PLANNING AND ZONING COMMISSION AGENDA-SPECIAL MEETING

STAFF REPORT
KETCHUM PLANNING AND ZONING COMMISSION
SPECIAL MEETING OF July 10th, 2017

PROJECT: Hotel Ketchum Coffee Shop

REQUEST: Pre-Application Design Review approval for a facility new Coffee Shop to replace the existing Bellemont Radio Station.

A300

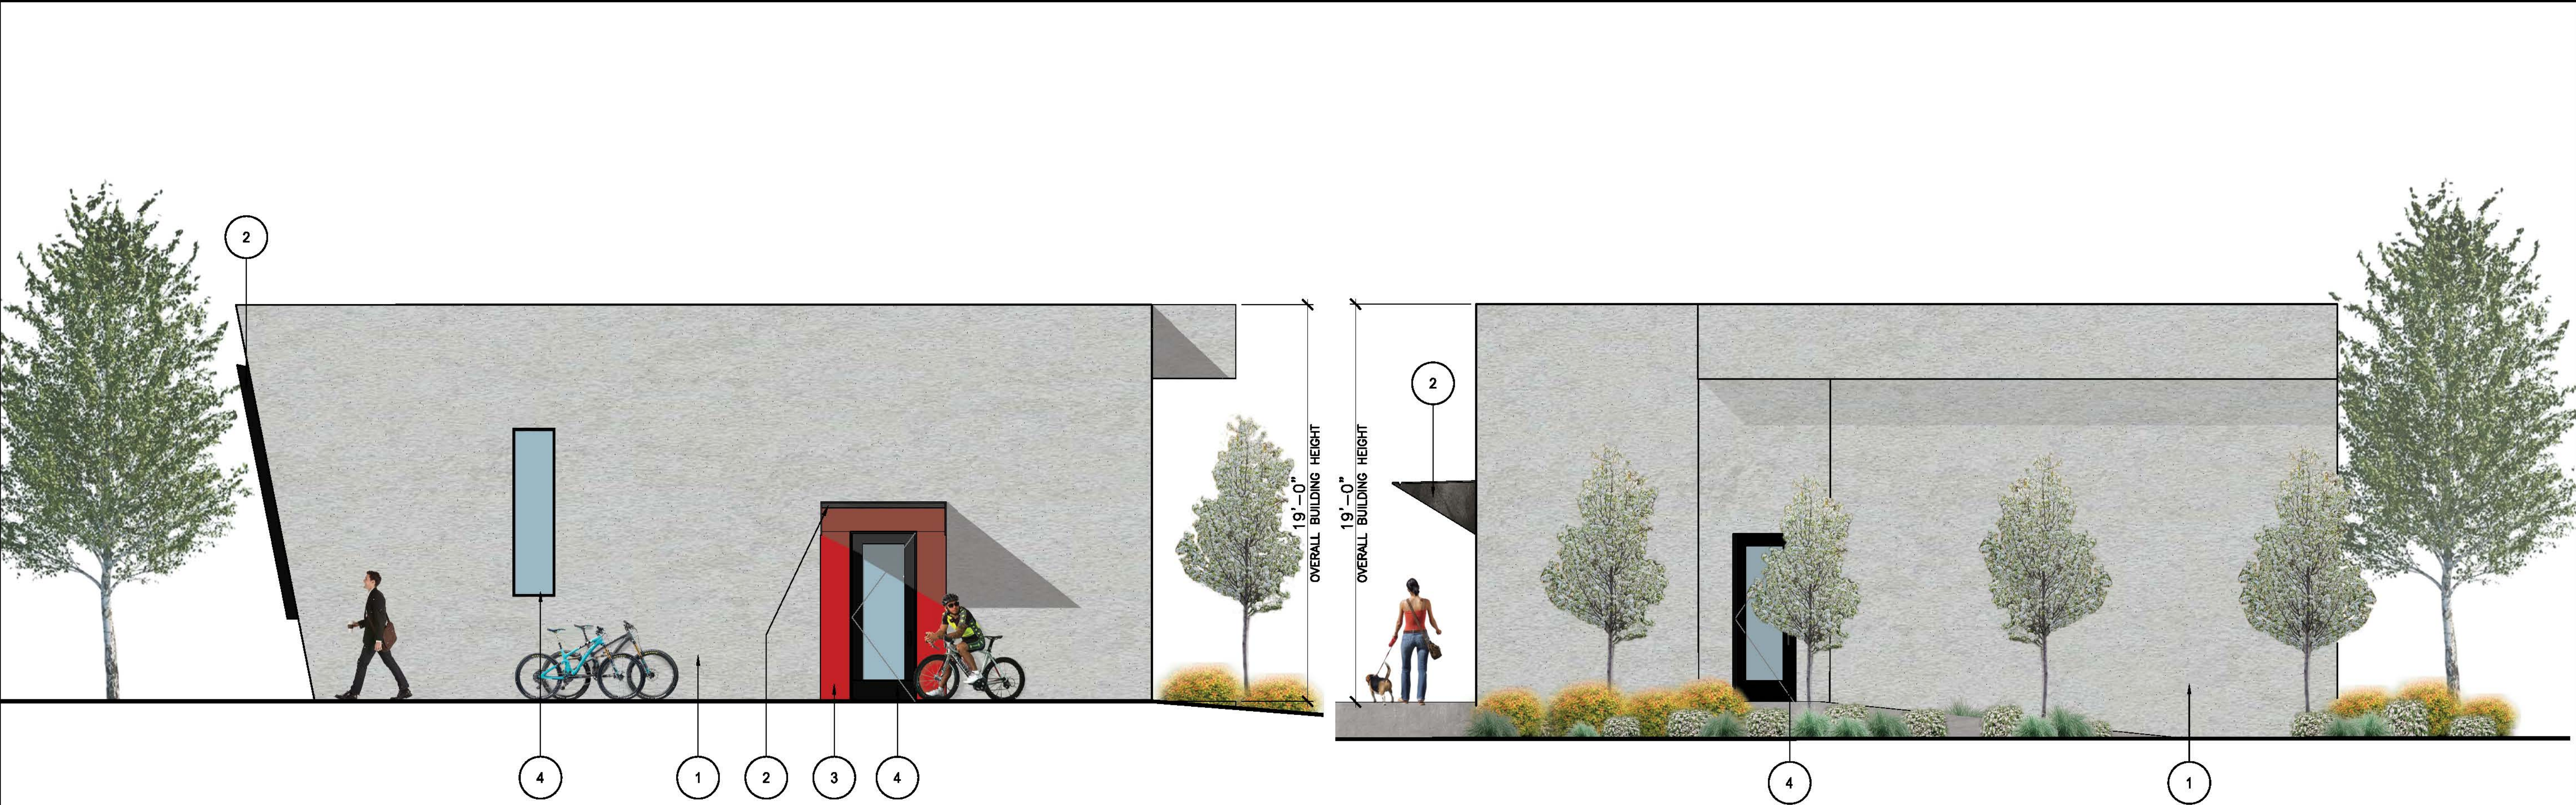
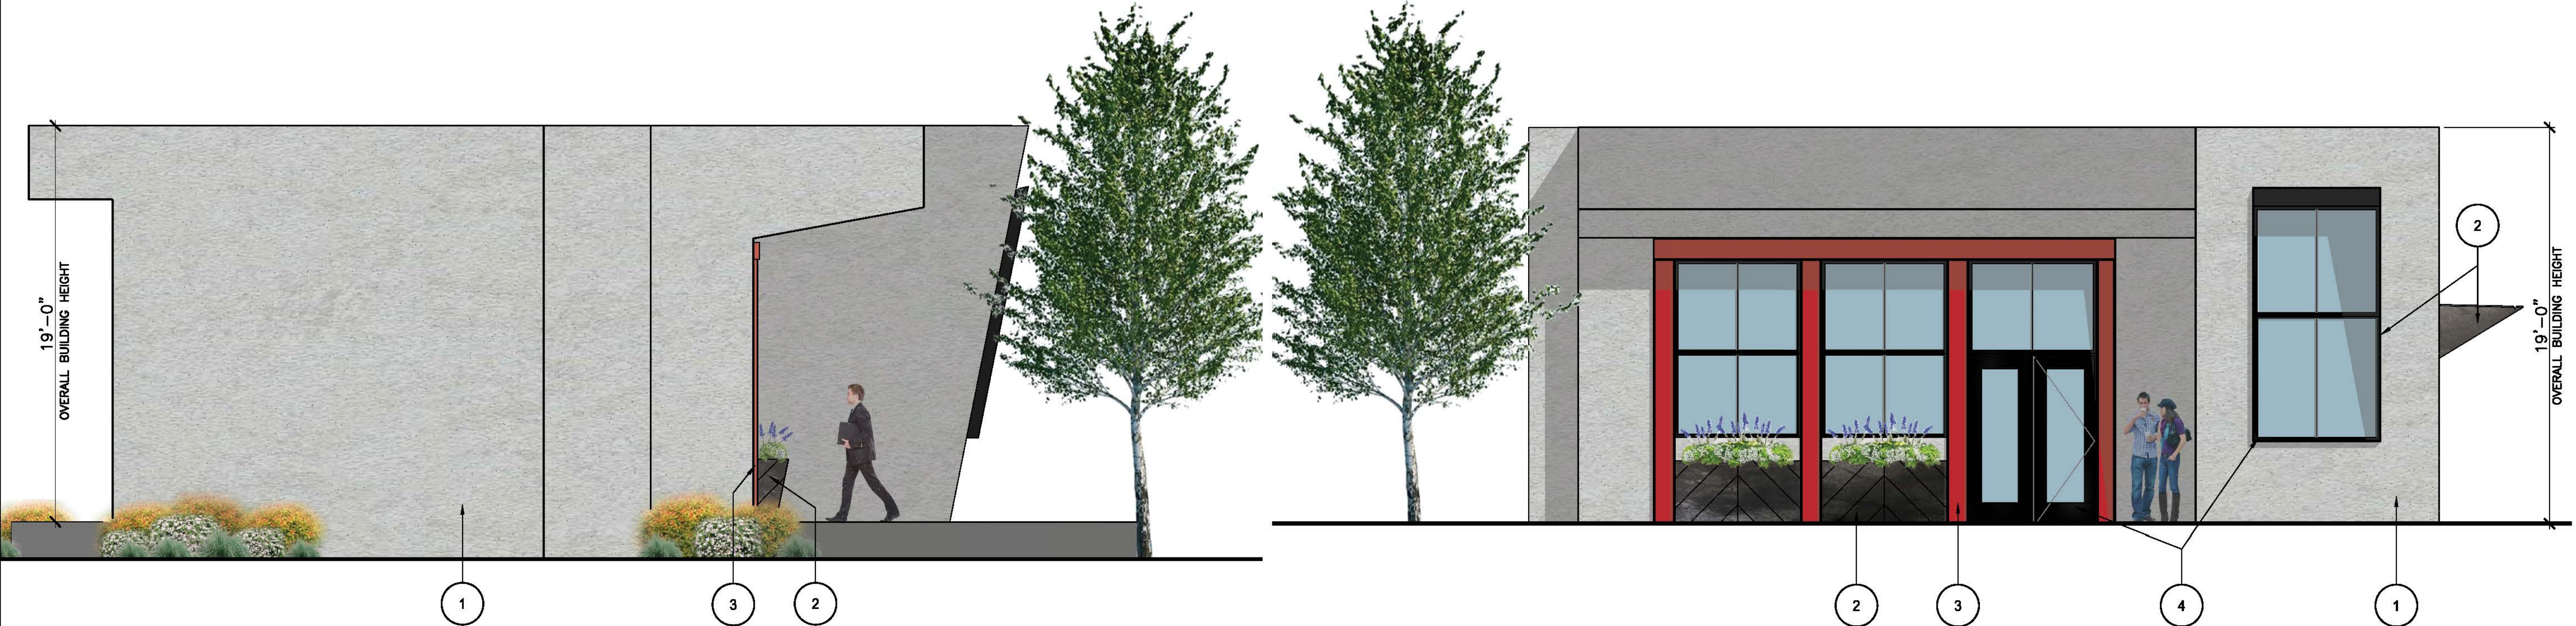
Staff Comments	<i>The existing building is currently noticed for demolition per chapter 15.16.040 Historic Demolition. The building will be demolished and the proposed coffee shop will be new construction.</i>
<input checked="" type="checkbox"/>	<input type="checkbox"/>	<input type="checkbox"/>	17.96.060(F)(1)	Building(s) shall provide unobstructed pedestrian access to the nearest sidewalk and the entryway shall be clearly defined.
			Staff Comments	<i>The proposed building and site layout provide unobstructed pedestrian accesses to the proposed sidewalk adjacent to N. Main St and the entryway is clearly defined.</i>
<input checked="" type="checkbox"/>	<input type="checkbox"/>	<input type="checkbox"/>	17.96.060(F)(2)	The building character shall be clearly defined by use of architectural features.
			Staff Comments	<p><i>The proposed Hotel Ketchum Coffee Shop is designed to be placed on the same foundation as the existing Bellemont Radio Station. The Coffee shop is single story and is clearly defined by the use of architectural features. The design includes the use of a slight overhang of the entrance from N. Main St. and a portion of the building extends towards the proposed terrace at the front of the building. The applicant also proposes planters underneath the windows at the front of the building. The combination of these design element provide depth to the structure and create an inviting atmosphere for pedestrian traffic and patrons of the coffee shop.</i></p> <p><i>The north portion of the coffee shop does not include windows and is left blank, with the exception of the gas fire place which extends to the property line. This side of the building includes landscaping to complement the north façade.</i></p> <p><i>The south facing façade includes a small overhang to provide shelter for pedestrian access at the side of the building. The applicant has utilized a vertical window and a side entrance, clad in the blackened steel, red painted steel and black aluminum, to break up the appearance of bulk at the south facing façade.</i></p> <p><i>The east façade serves as rear of the building will provide access for the staff of the coffee shop. The elevation contains an entry way for staff and a roof overhang to break up the massing of the façade.</i></p>

<input checked="" type="checkbox"/>	<input type="checkbox"/>	<input type="checkbox"/>	17.96.060(F)(3)	There shall be continuity of materials, colors and signing within the project.
			Staff Comments	<i>The materials shown provide a continuity of materials and colors for the project. The applicant is proposing hand troweled light-gray exterior plaster on all exterior walls. Blackened Steel is shown at the planters and window surround providing complement to light-gray plaster. Additionally, red painted steel window and door surround is shown at the front and south entrance of the proposed coffee shop, providing complement to the proposed black aluminum clad wood doors and windows.</i>
<input checked="" type="checkbox"/>	<input type="checkbox"/>	<input type="checkbox"/>	17.96.060(F)(4)	Accessory structures, fences, walls and landscape features within the project shall match or complement the principal building.

Staff Comments	<i>The proposed landscape features within the project complement the principal building and utilize the blackened steel window surround, planters and detailing.</i>
<input checked="" type="checkbox"/>	<input type="checkbox"/>	<input type="checkbox"/>	17.96.060(F)(5)	Building walls shall provide undulation/relief, thus reducing the appearance of bulk and flatness.
			Staff Comments	<i>The proposed building walls provide undulation/relief which will reduce the appearance of bulk and flatness. See staff comment in in section 17.96060.F.2 for further description.</i>
<input checked="" type="checkbox"/>	<input type="checkbox"/>	<input type="checkbox"/>	17.96.060(F)(6)	Building(s) shall orient towards their primary street frontage.
			Staff Comments	<i>The proposed Coffee Shop orients towards N Main St. which is the primary street frontage for the property. .</i>
<input checked="" type="checkbox"/>	<input type="checkbox"/>	<input type="checkbox"/>	17.96.060(F)(7)	Garbage storage areas and satellite receivers shall be screened from public view and located off alleys.
